Technical Memorandum

Re: J170084 – Whale Tail Project – Monitoring and Security Reduction – Update

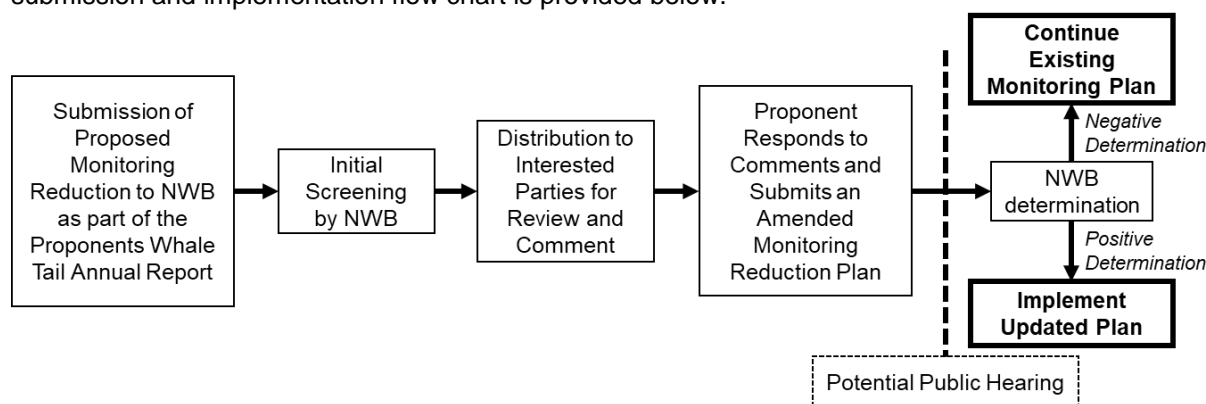
Recommendation 10: AEM should, as part of any application to the NWB for a reduction in closure or post closure monitoring, clearly outline which conditions of their proposed reduction framework are met according to the criteria above, including any forthcoming reduction triggers. Monitoring will not be reduced until the updated plan is approved by the NWB with appropriate input from interested parties. A conceptual submission and implementation flow chart is provided below.
